## MEMORANDUM

To: Town of Littleton Conservation Commission  
From: Dean Apostoleris, P.E.  
Kimley-Horn and Associates, Inc.  
Date: October 10<sup>th</sup>, 2024  
Subject: 151 Taylor St - Conservation Commission Comment Response

Pre-liminary Design 1: Connect to get Power from the Building

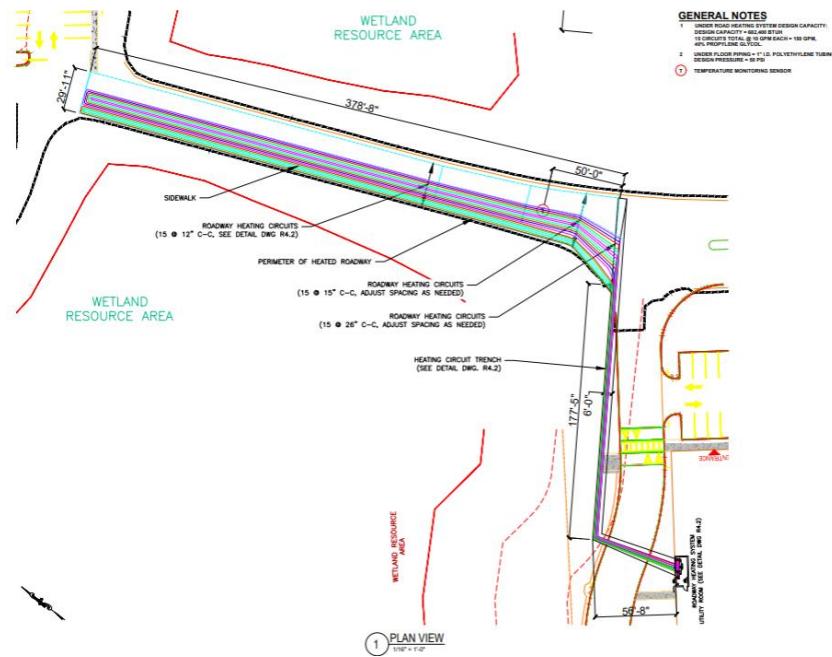
### 3. Alternatives to connecting power from elsewhere.

Option one was to provide a primary service to the site that would both energize the building and the proposed EV infrastructure as similarly shown in Pre-liminary Design 1. The impacts with this option are disturbance/clearance of trees back to the utility riser pole and a full replacement of the bridge heating system when attempting to install infrastructure to the parking lot. This would be very extensive with consideration to additional impacts to the wetlands, tress, and operation of the business. Figure #2 shows the heated bridge design. This design would not be feasible because the conduit run would be too long and there would be significant voltage drop by the time the site is reached.
